## **11.6 WILLIGOBUNG FIRE SHED - ATTACHMENTS**

**NSW Rural Fire Service  
Willigobung Brigade Station**

**Recommendations Report**

**Road Safety Audit**

**SNOWY VALLEYS COUNCIL  
BATLOW ROAD  
NSW RURAL FIRE SERVICE  
ROAD SAFETY AUDIT TREATMENTS  
STRATEGIC ROAD DESIGN**

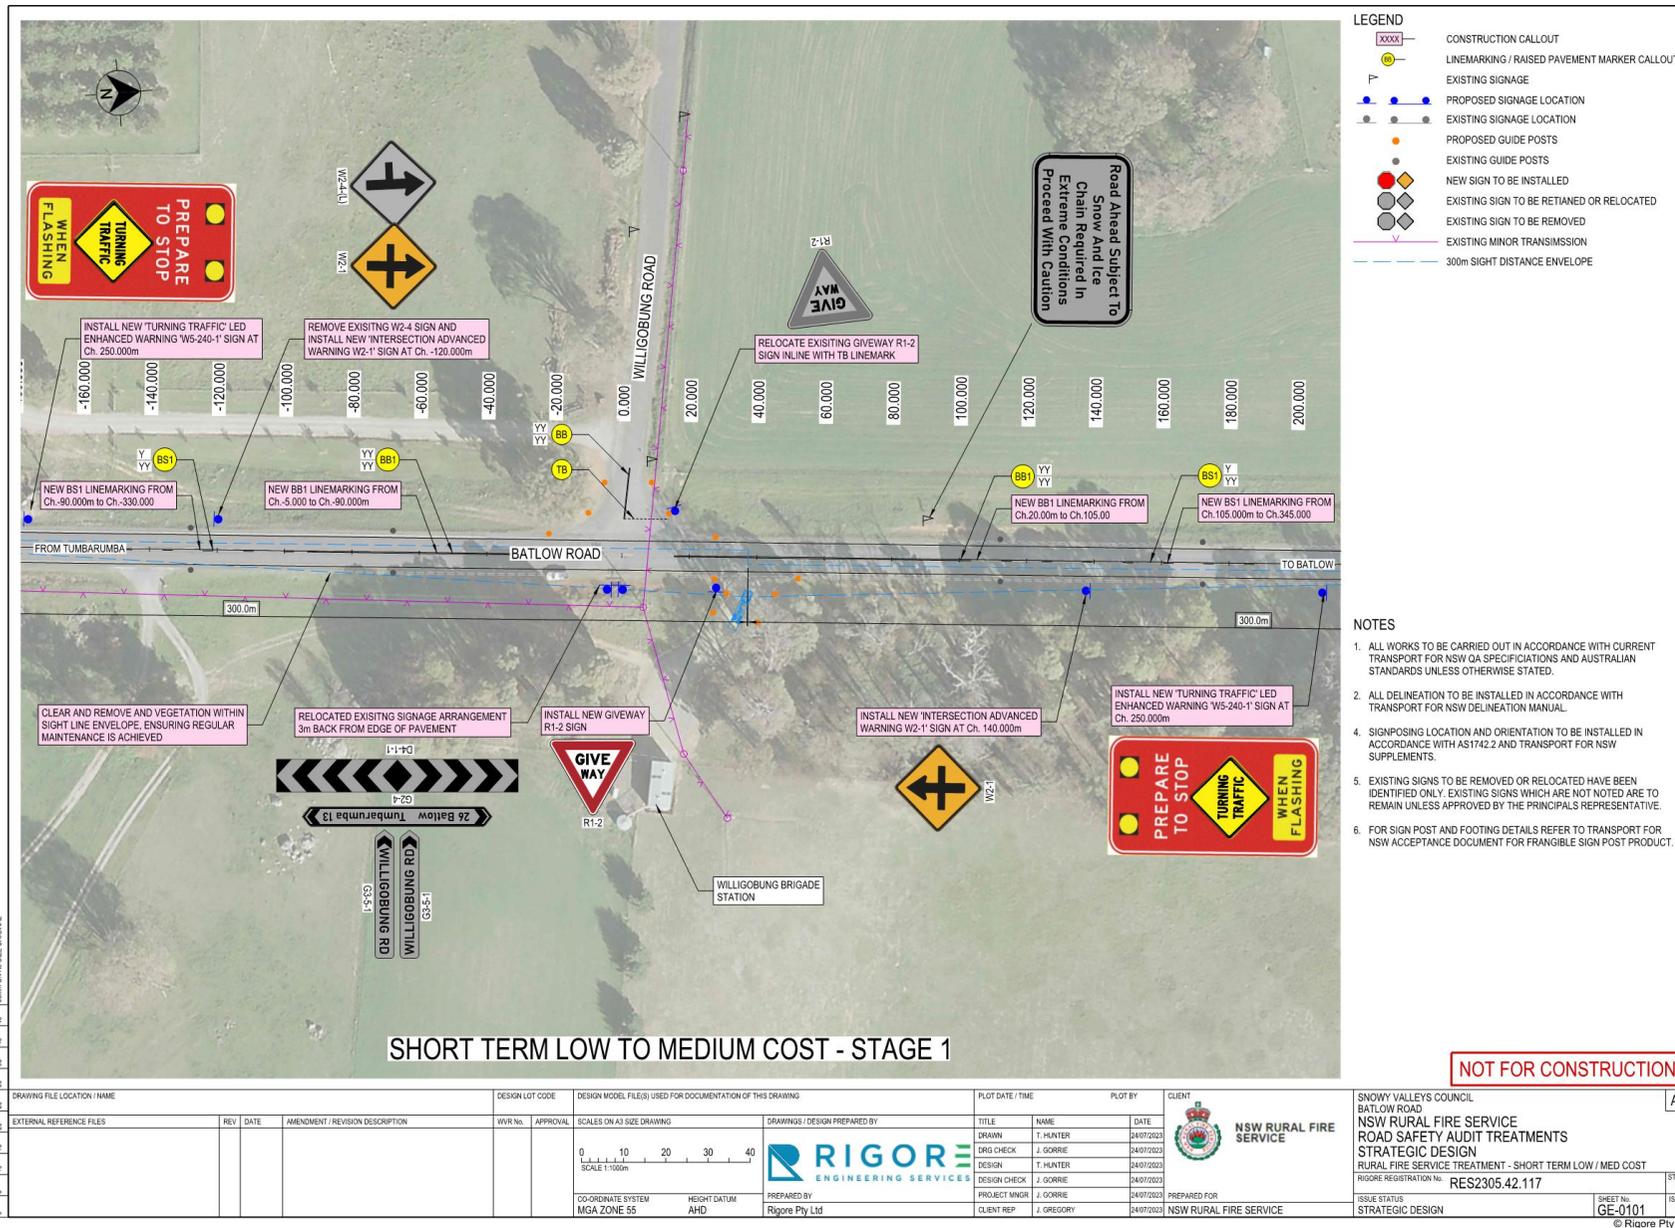
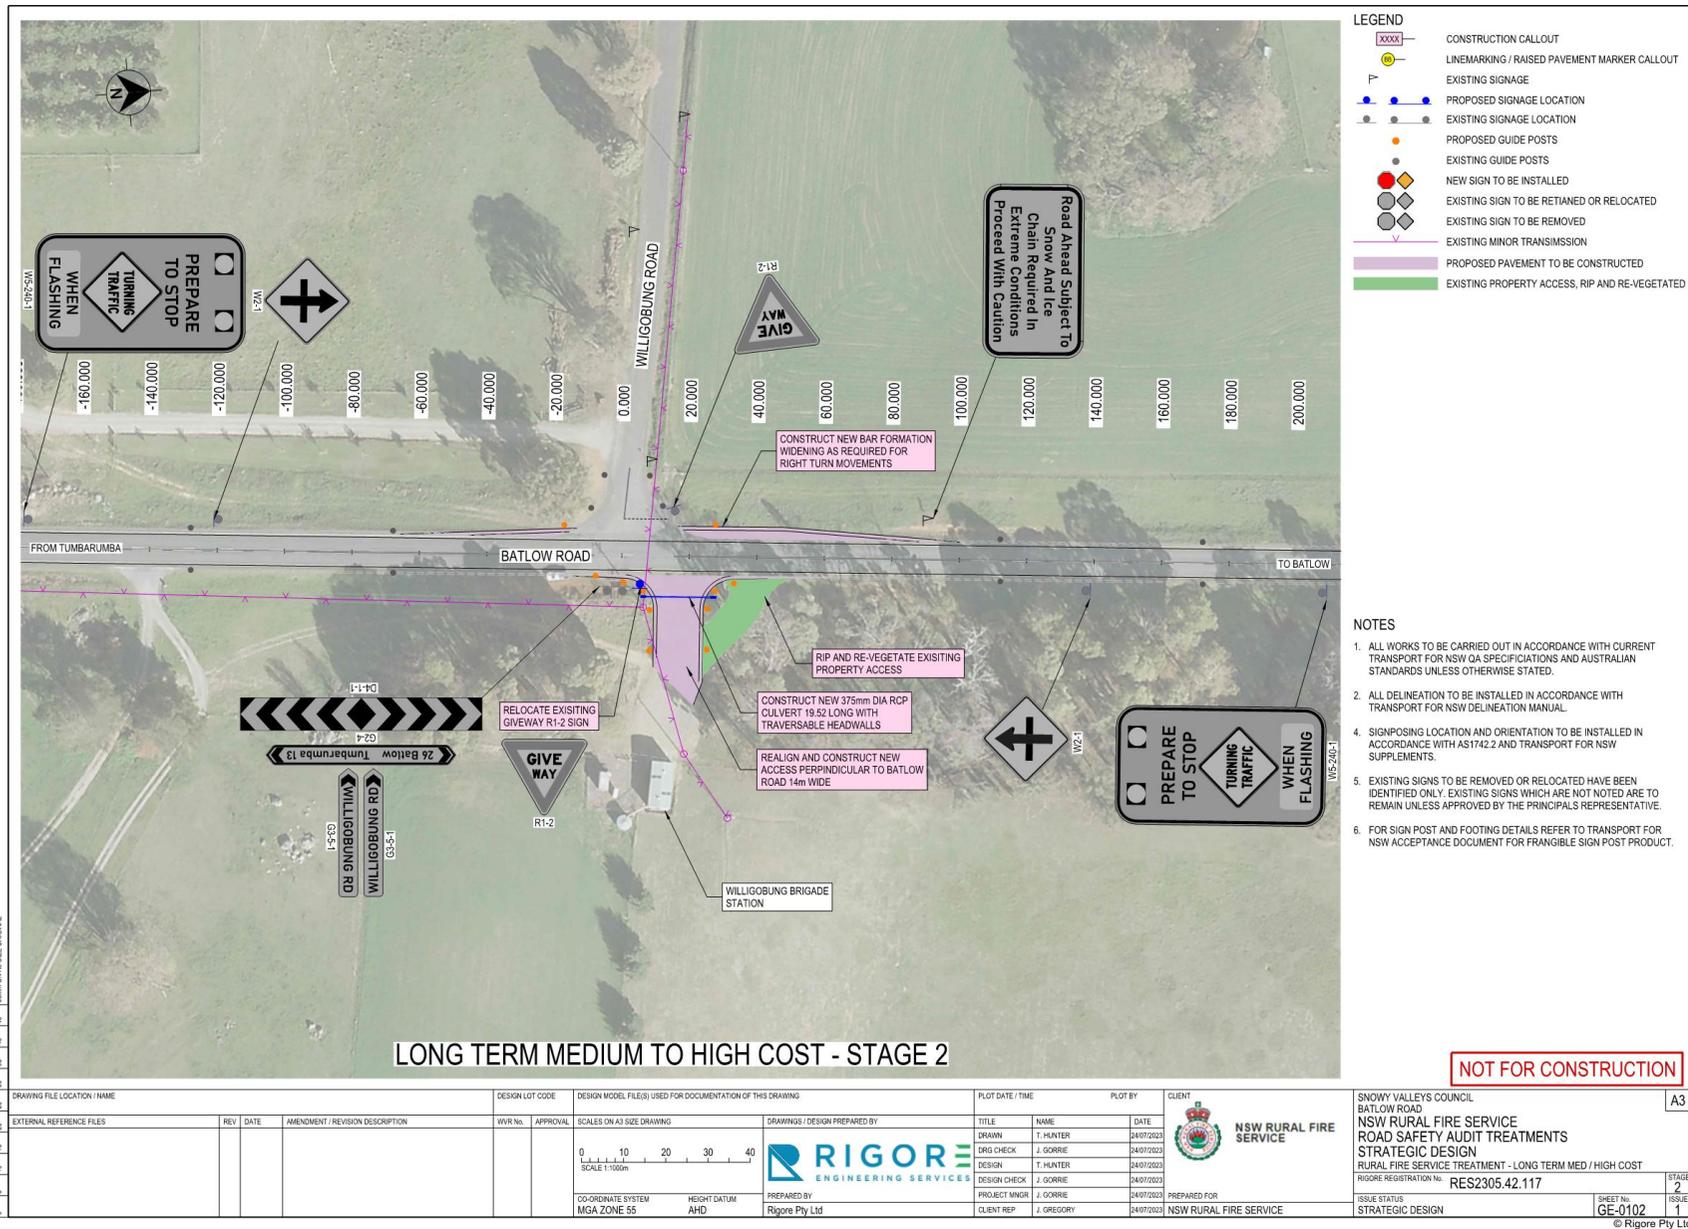
<p><b>LONGER TERM / HIGHER COST</b></p> <p>Implement the recommended actions as shown by Attachment A – Stage 2: Longer Term / Higher Cost Layout:</p> <ul style="list-style-type: none"> <li>- Provide an all weather access to the Willigobung Brigade Stations by realigning the access and installing a storm water culvert.</li> <li>- Provide a basic right turn treatment (BAR) to assist trailing road users to pass a right turning vehicle into the Willigobung Brigade Stations access.</li> </ul>					Rare			
								<b>RESIDUAL RISK</b>		
									<b>RESIDUAL RISK</b>

<p><b>LONGER TERM / HIGHER COST</b></p> <p>Implement the recommended actions as shown by <i>Attachment A – Stage 2: Longer Term / Higher Cost Layout</i>:</p> <ul style="list-style-type: none"> <li>- Provide an all weather access to the Willibobung Brigade Stations by realigning the access and installing a storm water culvert.</li> <li>- Provide a basic right turn tratement (BAR) to assit trailing road users to pass a right turning vehicle into the Willibobung Brigade Stations access.</li> </ul>	Rare				Moderate			
								<p><b>NOTES:</b></p> <ul style="list-style-type: none"> <li>- The excessive travel speeds recorded at the site will further reduce the time available for an approaching driver to react and brake.</li> </ul>

<p><b>LONGER TERM / HIGHER COST</b></p> <p>Implement the recommended actions as shown by <i>Attachment A – Stage 2: Longer Term / Higher Cost Layout</i>:</p> <ul style="list-style-type: none"> <li>- Provide an all weather access to the Willigobung Brigade Stations by realigning the access and installing a storm water culvert.</li> <li>- Provide a basic right turn treatment (BAR) to assist trailing road users to pass a right turning vehicle into the Willigobung Brigade Stations access.</li> </ul>			
							<b>RESIDUAL RISK</b>		<b>RESIDUAL RISK</b>

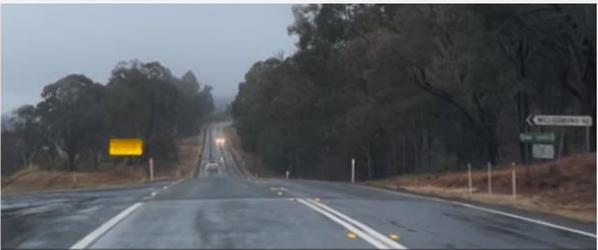
ID	Location	Photos / Reference	Description of Deficiency & Likely Consequence	Likelihood	Severity	Risk Level
ID-1	Northbound warning signage arrangement (~300m south of the intersection)	 <p>Looking north along Batlow Road towards Willigobung Road intersection and Brigade Station access.</p>  <p>W5-36 "Fire Station" W5-55-1n "Concealed Driveway"</p>	<p>The recent works involved the installation of W5-36 "Fire Station" paired with W5-55-1n "Concealed Driveway" warning signs. The advanced warning signage arrangement has been installed on the inside of a horizontal curve on the crest approximately 300m south of the intersection with Willigobung Road/Brigade Station access.</p> <p>However, should a northbound road user fail to observe, comprehend and react when required (refer to GO-1 above), it may result in high-speed intersection crash types involving road users travelling northbound on Batlow Road and those entering/exiting the Willigobung Brigade Station access. The likely travel speeds and impact angles may result in a high energy transfer at impact causing serious harm to occupants.</p> <p>Should a road user's attention be taken away from the roadway at a critical time on the approach to a substandard horizontal curve and vertical crest curve, this may cause drivers to stray outside the dedicated travel lane into oncoming traffic, resulting in head-on type collision at high speeds.</p> <p>NOTES: This hazard will be exacerbated during adverse weather and at nighttime when visibility is reduced.</p>	Rare	Serious	Medium (FSI)
